Title: Communication Overhead Description Schema for Multi Core Processor in Model-based

Development

1 Response to Meta-reviewer

Fig.1 System model.

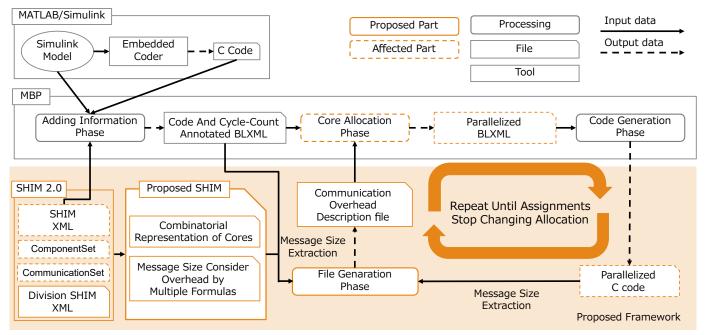
I wonder why the Parts for ComponentSet and CommunicationSet, which could be seen in the title of the sub-sub-section, did not appear in Figure 1 as seen in the title of the other sub-sub-section.

Thank you for your insightful comments and suggestions regarding our manuscript. In response to the review, we have updated Figure 1 to include the parts for ComponentSet and CommunicationSet. We also made minor modifications to the original system model and have clarified once again that our proposal builds upon the existing SHIM framework. We appreciate your insightful comments which have guided these enhancements. Thank you for helping us improve our work.
